10.4. State Significant Development Submission - Walker Street, North Sydney

The purpose of this report is to seek Council’s endorsement of the submission made to the Department of Planning Housing and Infrastructure in relation to a State Significant Development Application for a proposed residential development of 228 apartments on the corner of Walker and Hampden Streets, North Sydney.

Site Plan - SSD 67175465 East Walker Street North Sydney

Ground level plan, showing the ground plane and layout of each building, vehicle access, and seven parking spaces on the street (Rothelowman Architects).

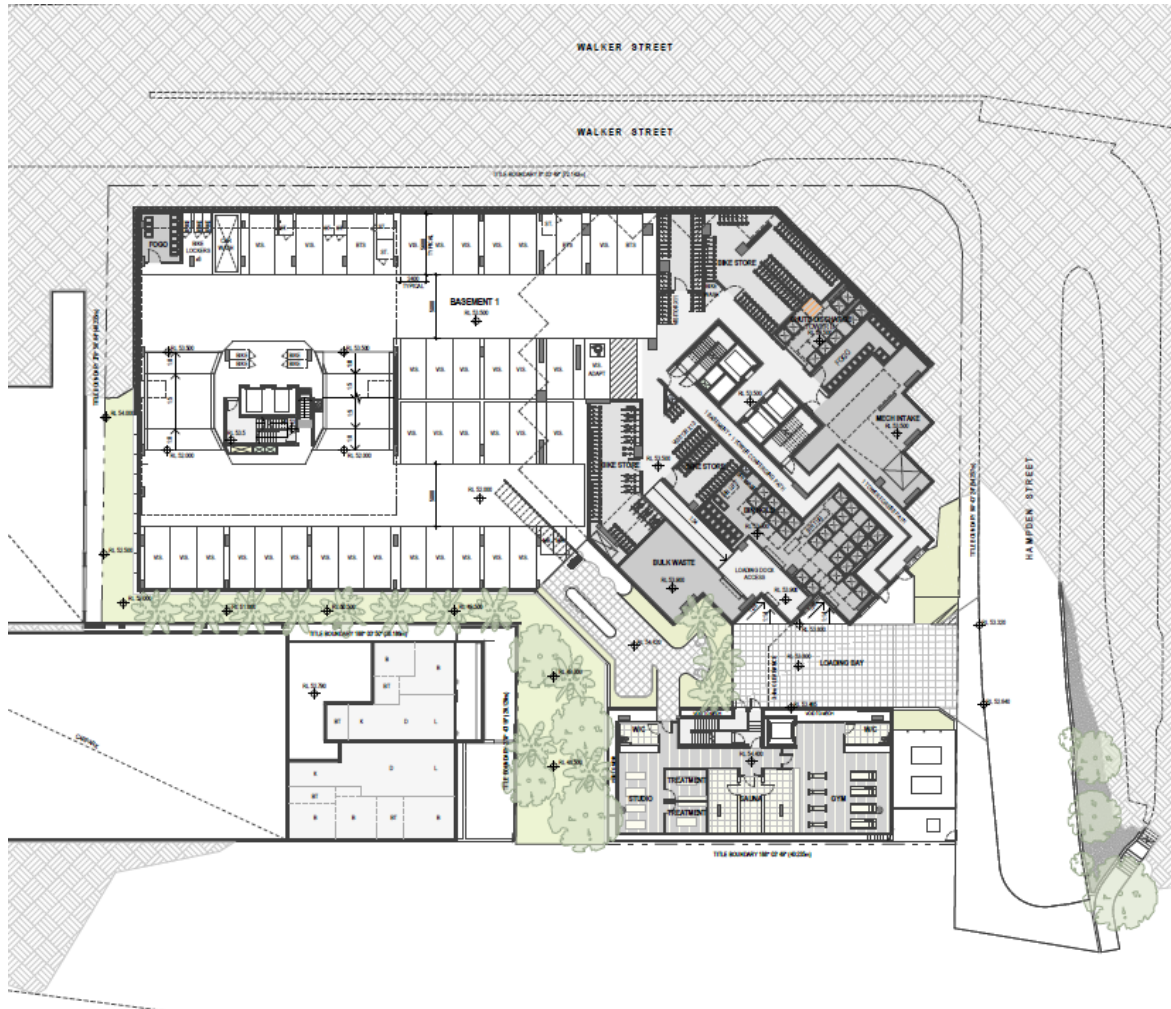
The number and width of the vehicle entry/exits result in the loss of on-street parking. Aerial imagery indicates there are up to 18 parking spaces on the Walker and Hampden Street opposite site frontages. The proposed ground floor plan shows only seven spaces will remain.

West elevation viewed across Walker Street (Rothelowman Architects)

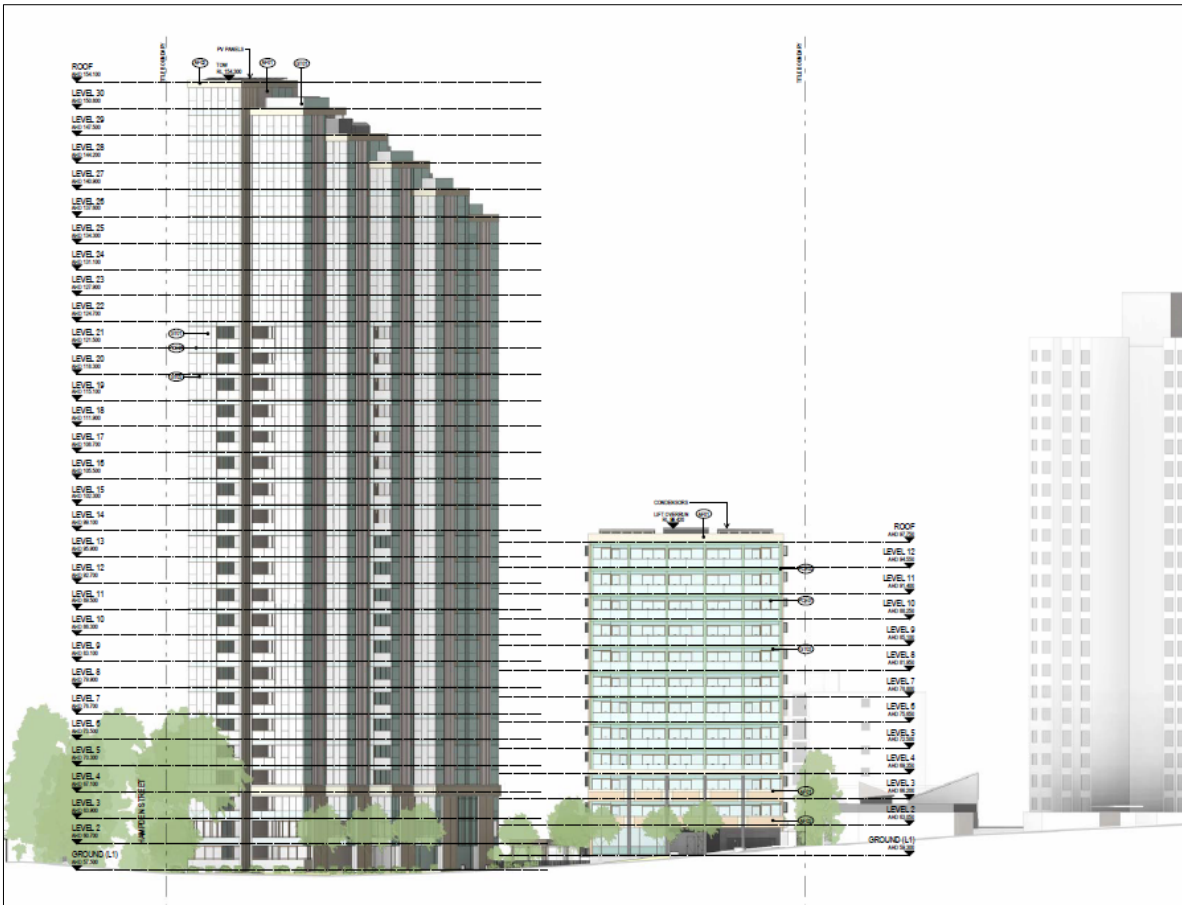
In contrast, Building A (the 12-storey affordable rental housing building) presents a continuous podium and tower form to Walker Street. The lack of above-podium setback, particularly to the street, increases its perceived bulk and mass, which is not in keeping with the desired street character. Increasing the podium setback to 3m on the western façade of Building A along Walker Street is recommended to enhance the human-scale quality of the streetscape.

The montage on the next page illustrates the contrast between the form of both podium and tower in Building A (to the right) and Building B1 (to the left). What seeks to unify the two buildings is the use of the stamped materials in the same colour at podium level, and hard and soft landscaping of the ground plane. Deeply recessed balconies in Building A should provide adequate summer-afternoon shade (also affected by other buildings to the west of Walker Street), whereas orientation and materials provide more effective environmental performance for the western façade of Building B1. The sawtooth façade of Building B1 and the flat face of Building A still mark them as distinct from one another, and

the recommended increasing of the above podium setback to 3m will assist in softening the appearance and bulk and scale of Building A.

1. Increase to 3 metres the above-podium setback provided to Building A's western façade.
2. The design be reviewed to clarify and make more legible and usable, the main entrances to Buildings A and B1, and clearly delineate between public and private spaces.
3. For the reasons outlined above and other reasons described elsewhere in this report, the porte cochere must be replaced with an on-street kerbside delivery and pick-up space, and the vehicular entry and loading bay on Hampden Street must be revised.
4. Consideration being given to enhancing the amenity provision for Building A, including equitable access to communal recreational spaces in Building B2, to ensure parity within the development overall.
5. ADG separation requirements should be fully complied with both within the site and to adjoining properties.
